# Access Compliance Report

## Public Rights-of-Way

### (Curb Ramps)

Intersection ID: 51519	Main Street: E JOHN BELK RA	Cross Street: SOUTH BV	Location: SW
ADA ID: BE9002075714	Ramp Type: Perp	Initial Pass/Fail: Fail	Overall Compliance: No
		Severity Score: 8.75

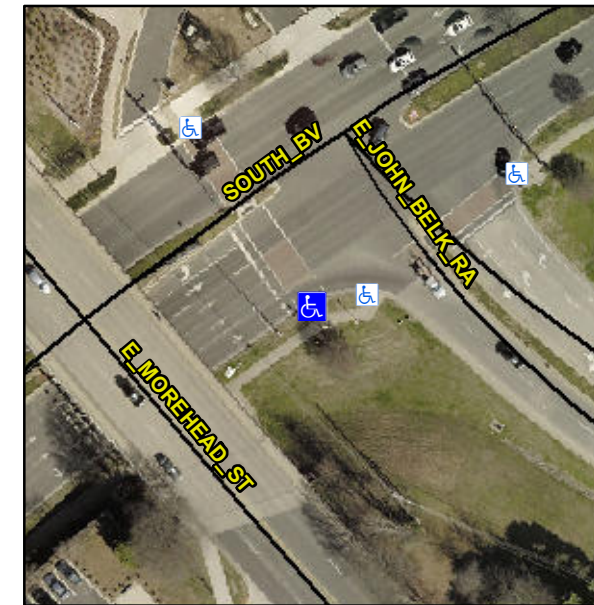
**R304.5.1**

Compliance	Description	Data	Compliance	Description	Data
N/A	Ramp Length (in)	96.0	Yes	Ramp Slope (%)	5.3
No	Ramp Width (in)	47.0	Yes	Ramp XSlope (%)	1.2
N/A	Flare Type LT	N/A	N/A	Flare Type RT	N/A
N/A	Flare Slope LT (%)	N/A	N/A	Flare Slope RT (%)	N/A
N/A	Flare Traversable LT?	N/A	N/A	Flare Traversable RT?	N/A
N/A	Landing Length (in)	N/A	N/A	DWS Provided?	N/A
N/A	Landing Width (in)	N/A	N/A	DWS Contrast?	N/A
N/A	Landing Slope (%)	N/A	N/A	DWS Length (in)	N/A
N/A	Landing X Slope (%)	N/A	N/A	DWS Full Width?	N/A
N/A	Landing Curb? (Y/N)	N/A	N/A	DWS Offset (in)	N/A
N/A	Shared Landing?	N/A			
N/A	Gutter Ponding?	N/A	N/A	Gutter Slope (%)	N/A
N/A	Gutter Lip Ht (in)	N/A	N/A	Gutter X Slope (%)	N/A
N/A	Painted X Walk1?	Yes	N/A	Painted X Walk2?	N/A
	X Walk 1 Direction	To NW		X Walk 2 Direction	N/A
N/A	X Walk 1 Width (in)	188.0	N/A	X Walk 2 Width (in)	N/A
	X Walk 1 Slope (%)	4.8		X Walk 2 Slope (%)	N/A
	X Walk 1 X Slope (%)	1.2		X Walk 2 X Slope (%)	N/A

**Remove & Replace Entire Ramp.**
